Watch Timing Marks on Flywheel when Replacing

How to Punch Mark Timing Gears

Figure 4

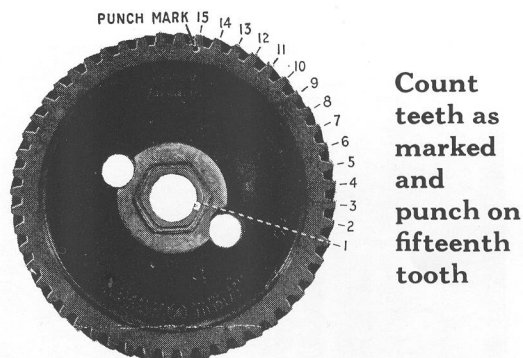
The statement on Page 43 of the Series AB Repair Manual is correct. The illustration on Page 42 of Series AB Gears, however, does not tie in with the instructions.

In Fig. 4 is shown the camshaft gear. This marking is located by starting to count with the tooth exactly opposite the keyway as indicated. Calling this tooth No. 1, count anti-clockwise, or to the left, 15 teeth and punch mark the fifteenth tooth.

These statements apply to all gears whether fabric or steel.

Figure 5

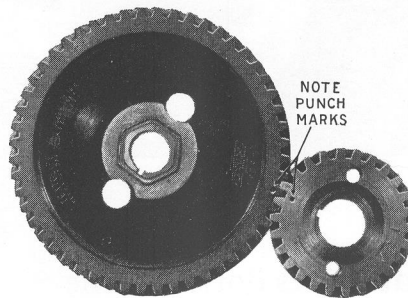
When mated properly, the tooth which is marked on camshaft gear should be matched with the mark on crankshaft gear as illustrated in Fig. 5.
